UNITED STATES  
DEPARTMENT OF THE INTERIOR  
BUREAU OF LAND MANAGEMENT

FORM APPROVED  
OMB NO. 1004-0137  
Expires: January 31, 2018**SUNDRY NOTICES AND REPORTS ON WELLS**  
*Do not use this form for proposals to drill or to re-enter an abandoned well. Use form 3160-3 (APD) for such proposals.*5. Lease Serial No.  
NMLC060549

☒ Oil Well ☐ Gas Well ☐ Other8. Well Name and No.  
TROLL 10 FEDERAL 012. Name of Operator  
COG OPERATING LLCContact: ABIGAIL ANDERSON  
E-Mail: abbym@bcmadassociates.com9. API Well No.  
30-025-36034-00-S13a. Address  
ONE CONCHO CENTER 600 W ILLINOIS AVENUE  
MIDLAND, TX 79701-42873b. Phone No. (include area code)  
Ph: 432-580-716110. Field and Pool or Exploratory Area  
TONTON

**Permanent Abandonment of Federal Wells  
Conditions of Approval (LPC Habitat)**

# CURRENT WELLBORE SCHEMATIC

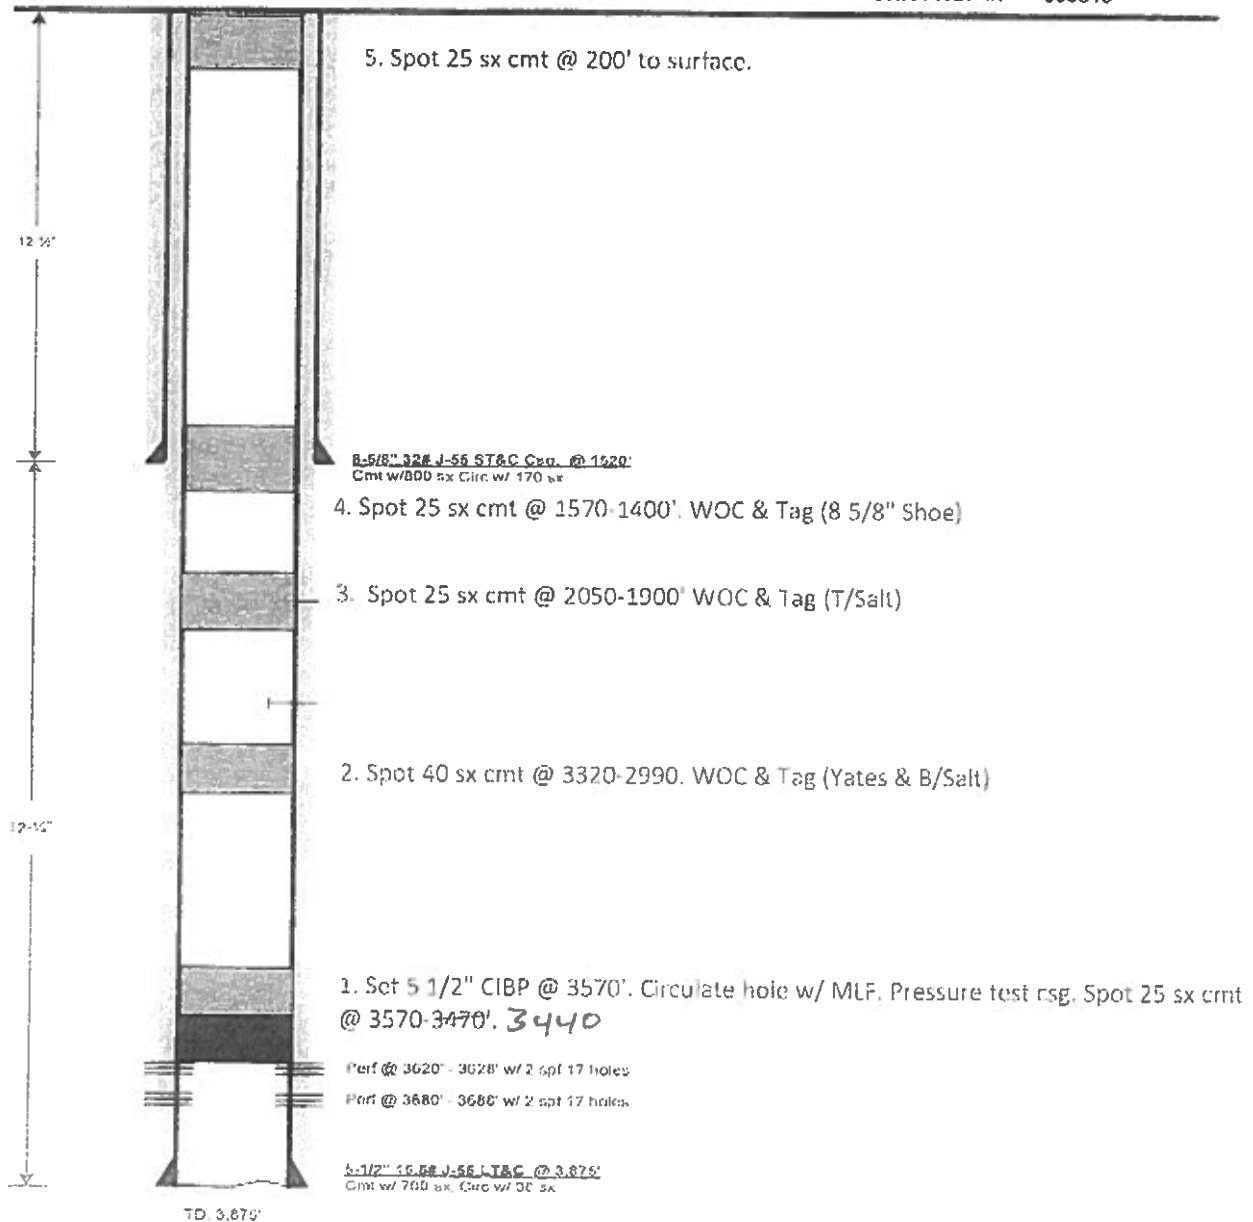
- Set 5 1/2" CIBP @ 3570'. Circulate hole w/ MLF. Pressure test csg. Spot 25 sx cmt @ 3570-3470' **3440**
- Spot 40 sx cmt @ 3320-2990. WOC & Tag (Yates & B/Salt)
- Spot 25 sx cmt @ 2050-1900' WOC & Tag (T/Salt)
- Spot 25 sx cmt @ 1570-1400' WOC & Tag (8 5/8" Shoe)
- Spot 25 sx cmt @ 200' to surface.
- Cut off well head, verify cmt to surface, weld on Below Ground Dry Hole Marker.

**SEE ATTACHED FOR  
CONDITIONS OF APPROVAL***Below ground level dry hole marker required*
